EDGEMONT - PHASE 3

PRELIMINARY SUBDIVISION PLAN

WENDELL, NORTH CAROLINA

APRIL 2, 2020

SHEET NO: C1.0

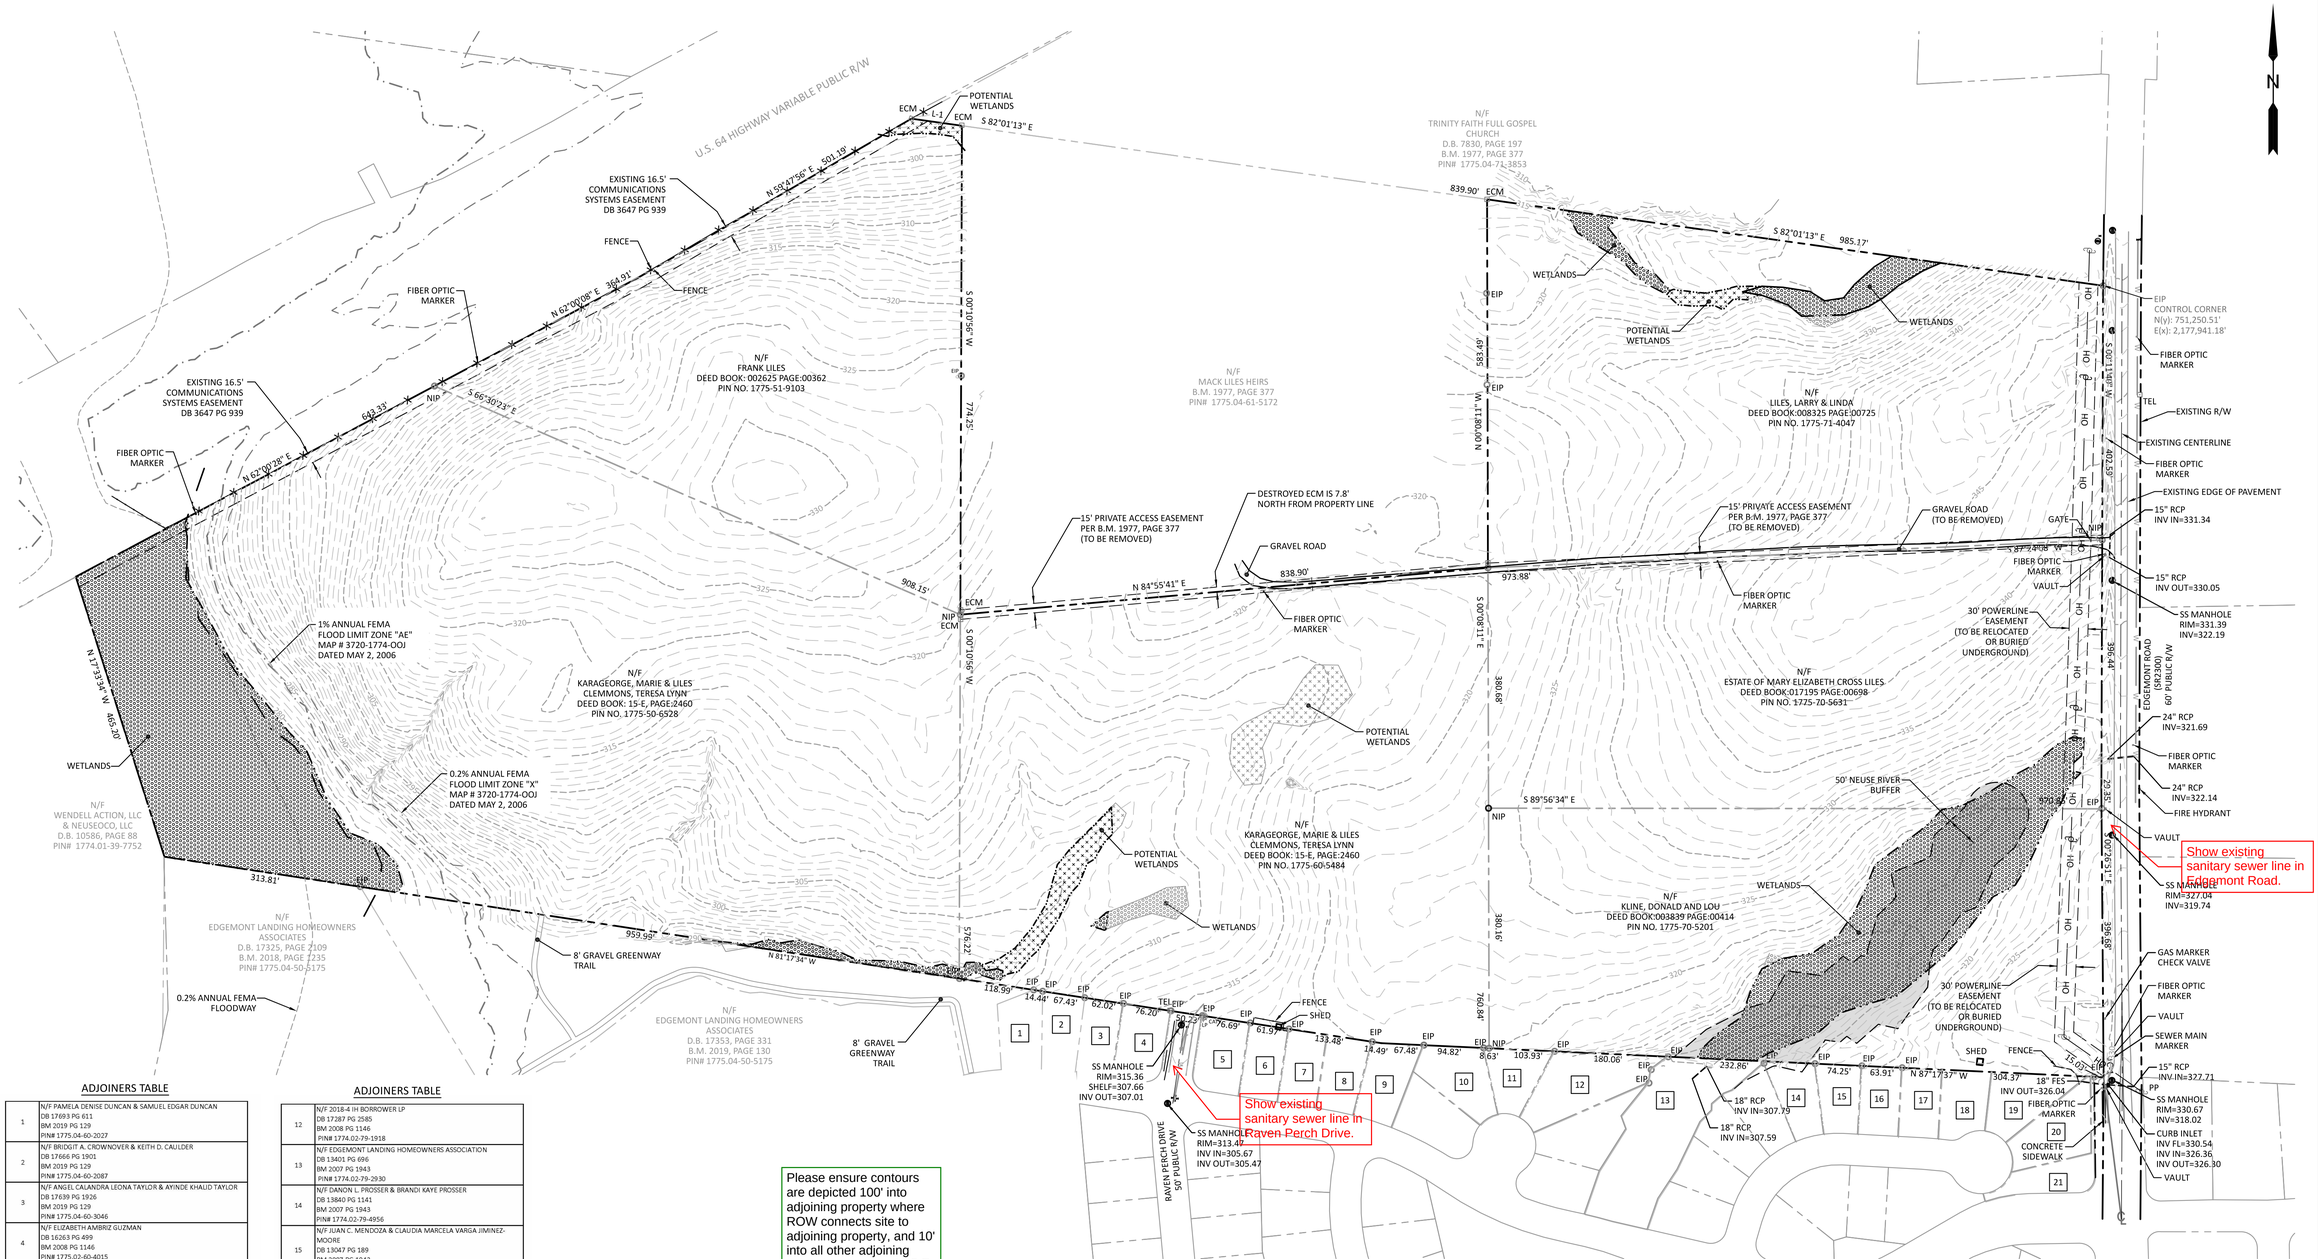
Please ensure contours are depicted 100' into adjoining property where ROW connects site to adjoining property, and 10' into all other adjoining properties per req. 16.5.E.

When can you confirm the wetlands?

LOCAL STREET TYPICAL SECTION

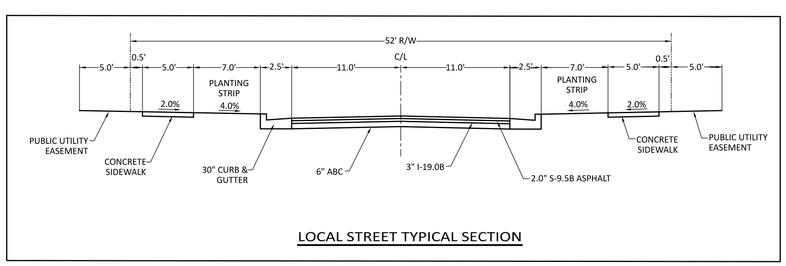
Typical sight triangles on development roads are 25'x25' per 9.3.E.3. NCDOT sight triangles are used at intersections onto State Roads.

Please label and dimension sight triangles (typ. if applicable)

PROJECT NO: ---
DESIGN BY: JDA
DRAWN BY: JDA
SCALE: 1"=120'
DATE: 2020-04-02
SHEET NO: C3.0

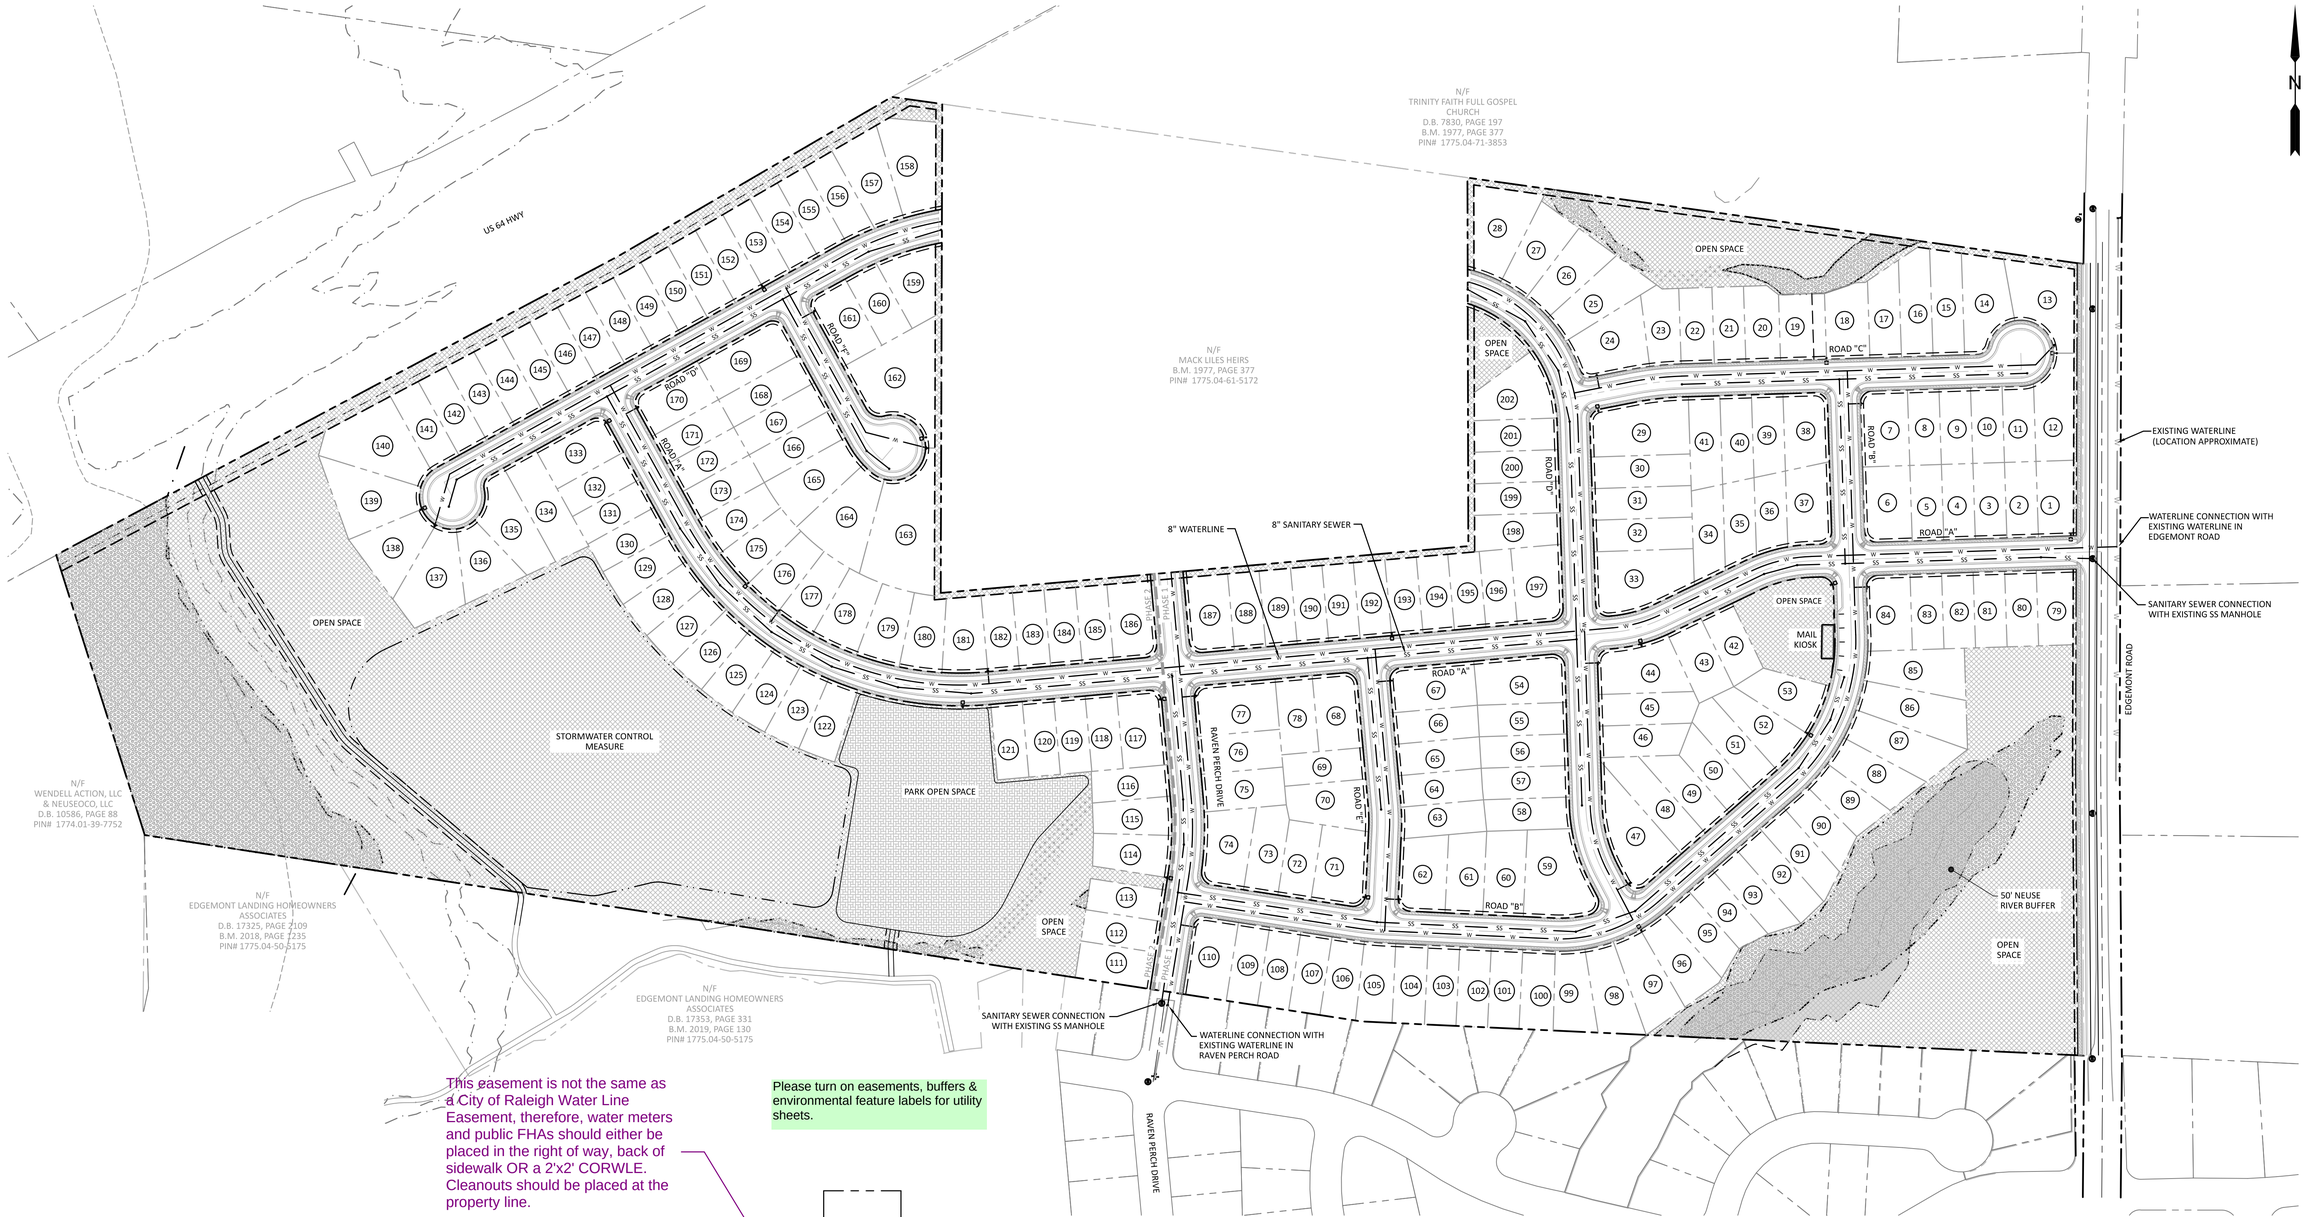
This easement is not the same as a City of Raleigh Water Line Easement, therefore, water meters and public FHAs should either be placed in the right of way, back of sidewalk OR a 2'x2' CORWLE. Cleanouts should be placed at the property line.

Please turn on easements, buffers & environmental feature labels for utility sheets.
